Access Compliance Report

(Curb Ramps)

Intersection ID: 23929	Main Street: BROADWATER_LN	Cross Street: STEPHENDALE_DR	Location: NW
ADA ID: 395B87703BC3	Ramp Type: Directional1	Initial Pass/Fail: Fail	Overall Compliance: No
Severity Score: 21.25			
Codes/Mitigation Info/Possible Solution		Field Measurements/Component Compliance

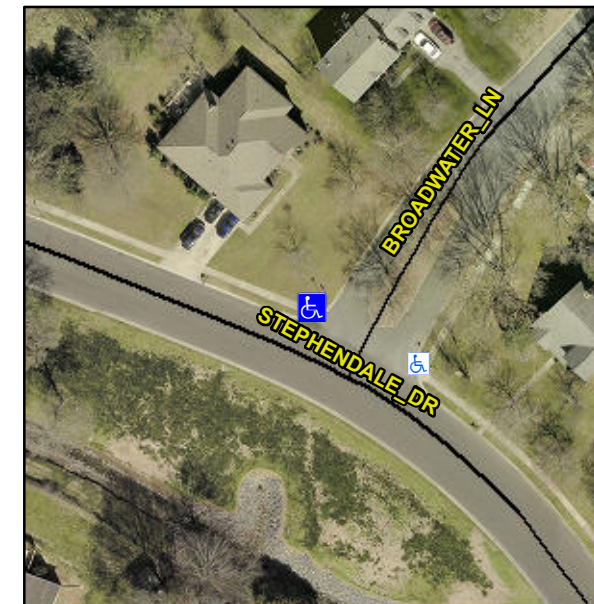
R304.5.1, R304.5.3

Compliance	Description	Data	Compliance	Description	Data
N/A	Ramp Length (in)	50.0	N/A	Grade Break?	N/A
No	Ramp Width (in)	42.0	N/A	Grade Break Slope (%)	0.0
Yes	Ramp Slope (%)	6.2	N/A	Grade Break XSlope (%)	0.0
No	Ramp XSlope (%)	6.1			
N/A	Flare Type LT	N/A	N/A	Flare Type RT	N/A
N/A	Flare Slope LT (%)	N/A	N/A	Flare Slope RT (%)	0.0
N/A	Flare Traversable LT?	N/A	N/A	Flare Traversable RT?	N/A
N/A	Landing Length (in)	0.0	N/A	DWS Provided?	N/A
N/A	Landing Width (in)	0.0	N/A	DWS Contrast?	N/A
N/A	Landing Slope (%)	0.0	N/A	DWS Length (in)	N/A
N/A	Landing X Slope (%)	0.0	N/A	DWS Full Width?	N/A
N/A	Landing Curb? (Y/N)	N/A	N/A	DWS Offset LT (in)	N/A
N/A	Shared Landing?	N/A	N/A	DWS Offset RT (in)	N/A
N/A	Gutter Ponding?	0.0	N/A	Gutter Slope (%)	N/A
N/A	Gutter Lip Ht (in)	0.0	N/A	Gutter X Slope (%)	N/A
N/A	Painted X Walk1?	No		Road Slope (%)	2.3
	X Walk 1 Direction	To E		Road X Slope (%)	1.8
	X Walk 1 Width (in)	N/A		Clear Space?	N/A

Remove & Replace Entire Ramp.
